Swan_soundbar DVT3 soldering review

ALT Co., Ltd.

Issued Date 2021.08.30

Ver.1.0

• SoC PCBA - Defect

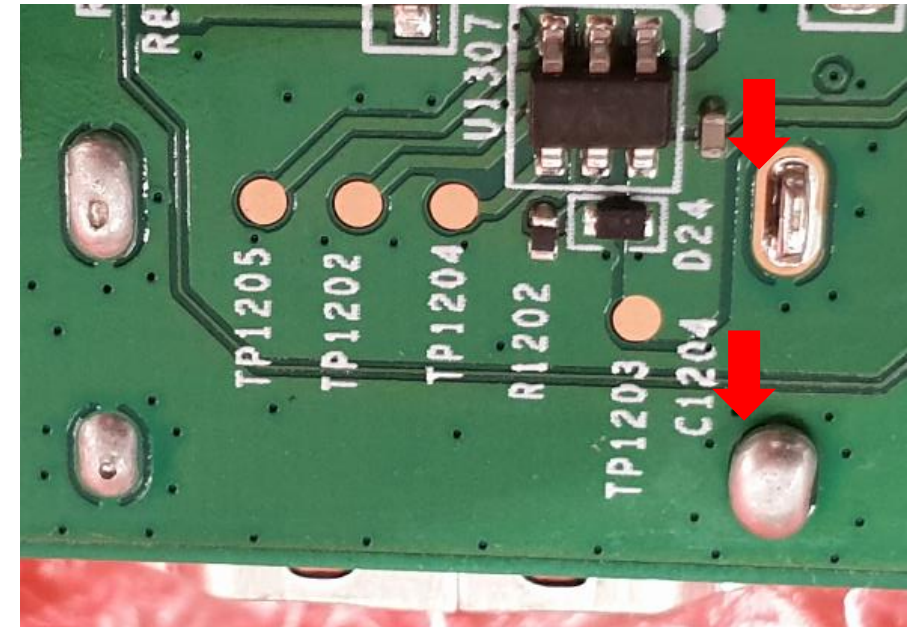
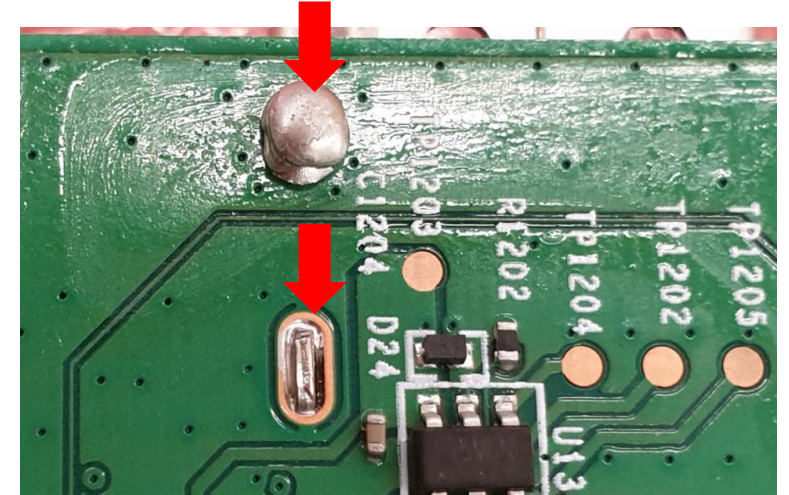
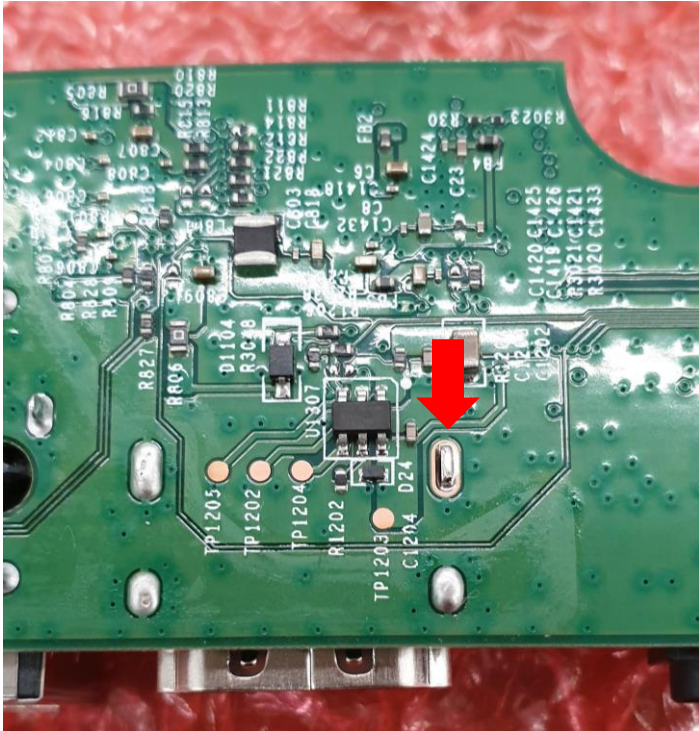
- GND PIN not fully fill up - Defect.
 - 100%
- GND PIN soldering defect - lump of solder
 - 80%

• AMP PCBA - Defect

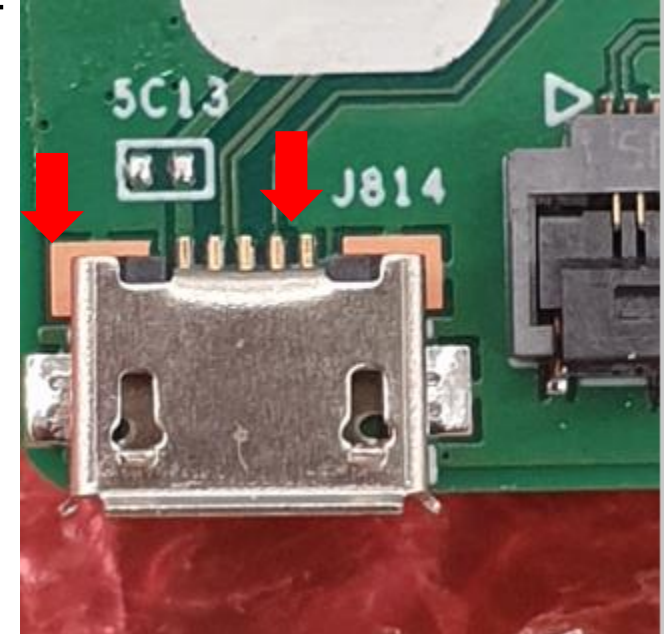
- GND PIN not soldered.
 - 100%
- GND signal pin lack of solder
- Metal mask design must be updated
 - Report the before / after metal mask design for J814

- AMP PCBA - Defect

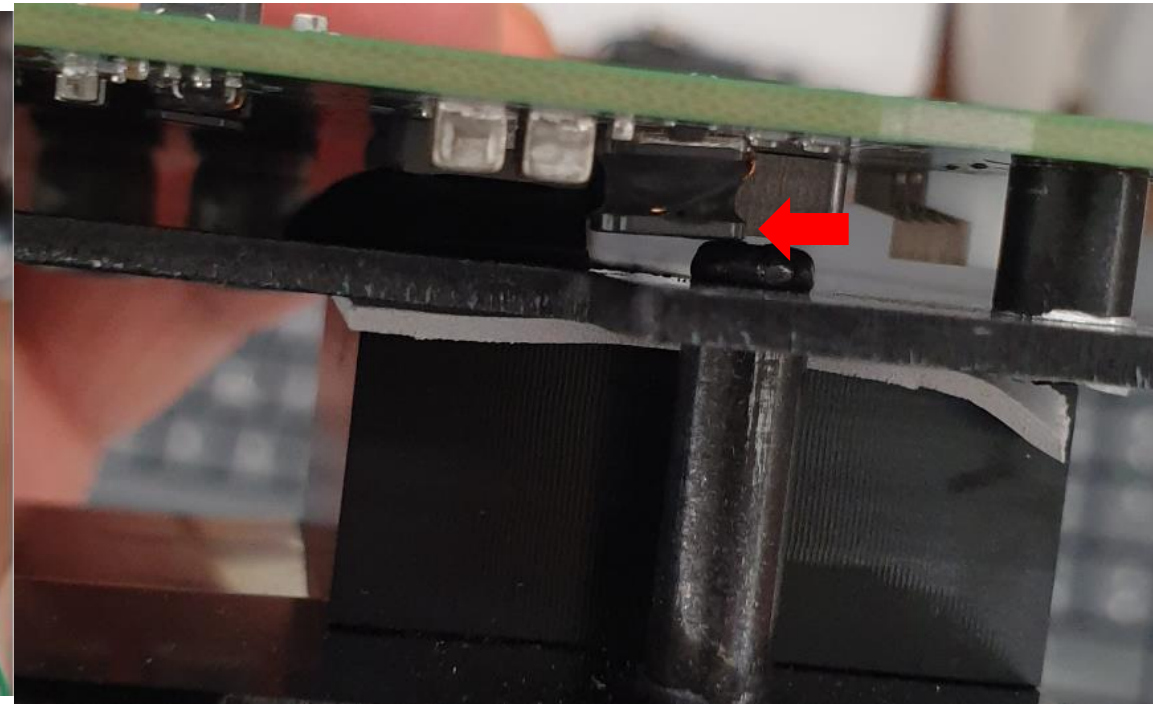
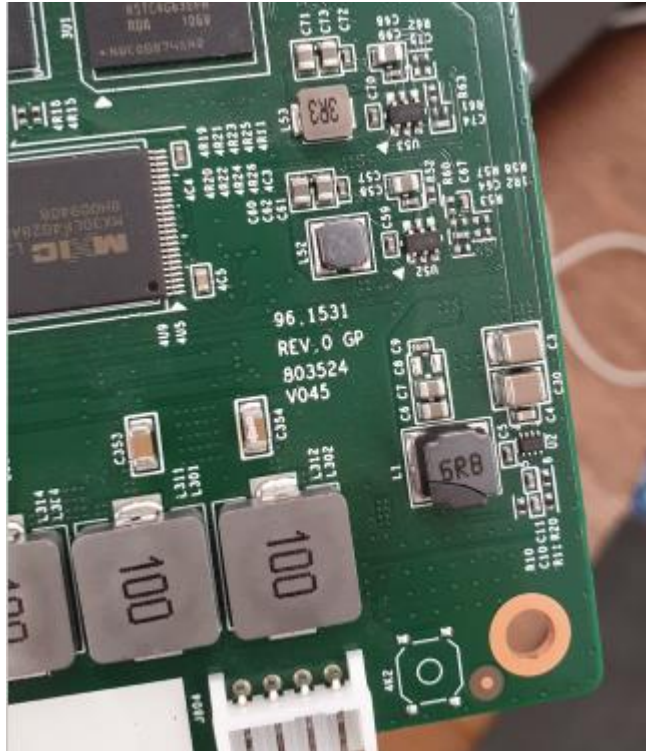
- Inductor L1 broken
 - 100%
 - Touched with heat spreader
